DC Jack_12V

USB C - POWER BANK INPUT

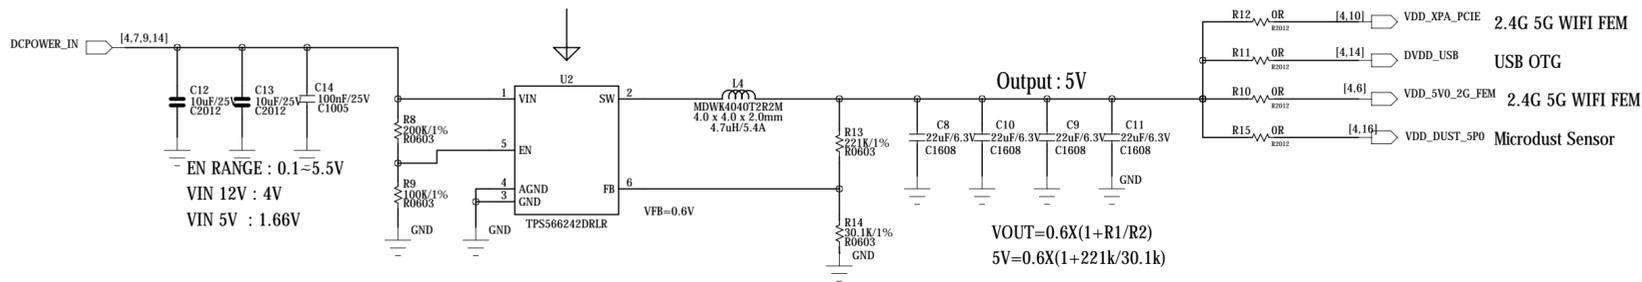
U403, U404, U406, U401 DCDC Change from AP62600 to TPS566242DRLR
